Access Compliance Report Public Rights-of-Way (Curb Ramps)

Main Street: N/A Cross Street: SIENNA_PKWY Location: SW

ADA ID: RPRK220223172630 Ramp Type: Type 6 - Directional 1 Initial Pass/Fail: Pass Overall Compliance: No Severity Score: 15

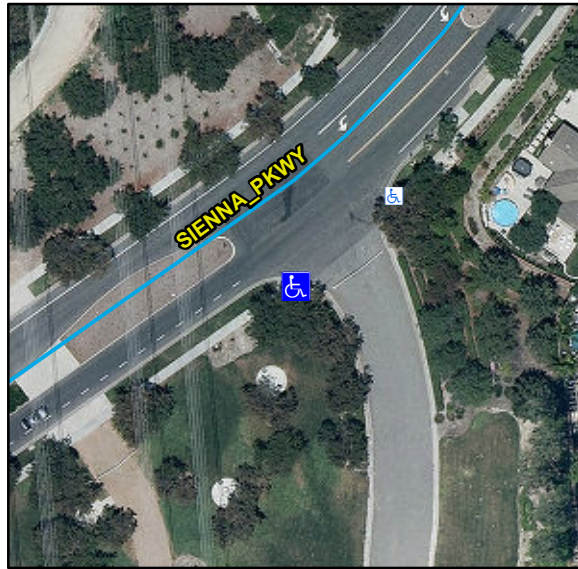
Remove & Replace Entire Ramp. Remove & Replace Gutter.

R304.5.2, R305, R304.5.4, STD 1115
